Document Review Comment Sheet

PEB Ref. No : TB2-PEB-SDC-M1B-TVI-02734

DOCUMENT SUBMISSION STATUS:									
NOTE:									
	24 FEB.2014	FOR FINAL				S.W.E.	H.K.LEE	J.C.YOON	S.S.KIM
	27 DEC.2013	BY OWNER COMMENT				S.W.E.	H.K.LEE	J.C.YOON	S.S.KIM
	11 SEP.2013	BY OWNER COMMENT				S.W.E.	H.K.LEE	J.C.YOON	S.S.KIM
	20 MAY 2013	FOR PRELIMINARY				S.W.E.	H.K.LEE	J.C.YOON	S.S.KIM
REV	DATE	DESCRIPTION				PREP	CHKD	APRD	APRD
OWNER		OWNER'S CONSULTANT							
 VIETNAM OIL AND GAS GROUP (PVN)		 FICHTNER GmbH & Co. KG				 PV POWER PCC			
EPC CONTRACTOR		EPC CONTRACTOR'S CONSULTANT							
 PETROVIETNAM CONSTRUCTION JOINT STOCK CORPORATION (PVC)		 WorleyParsons resources • energy WORLEYPARSONS							
POWER ISLAND PACKAGE SUPPLIER		 DAELIM DAELIM INDUSTRIAL CO., LTD.							
PROJECT TITLE		THAI BINH2 THERMAL POWER PLANT 2 x 600MW

DRAWING TITLE		HP FEEDWATER HEATER #6 11LAD10AC006/21LAD10AC006 DRAIN COOLING SUB ASSEMBLY						 SHEET 5 / 19	
VENDOR NAME		FUNCTION		NAME		SIGN		DATE	
 WOORYANG HC CO., LTD		DRWN		S.W.E.				24 FEB.2014	
		CHKD		H.K.LEE				24 FEB.2014	
		APPD		J.C.YOON				24 FEB.2014	
		APPD		S.S.KIM				24 FEB.2014

FIG. UG-118 FORM OF STAMPING

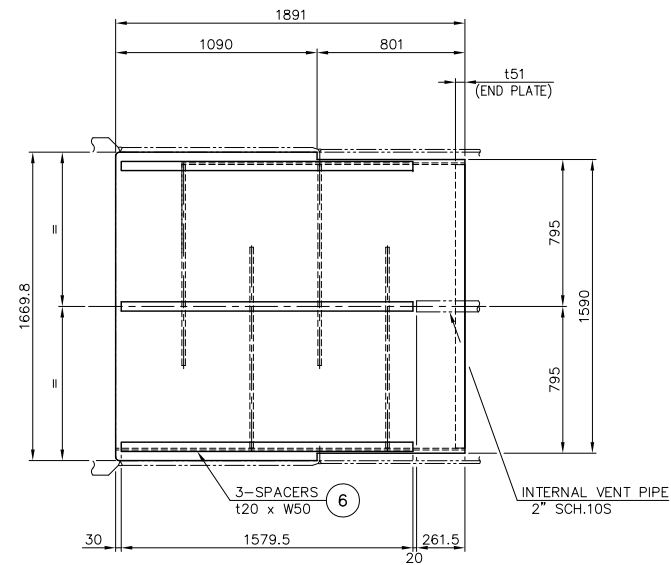
2	Please note that: Nameplates shall be in English with a minimum letter size of 6.4 mm.		ASME 'U'stamp project letter size was min 4mm.(UG-108). But we will used letter size 7mm.
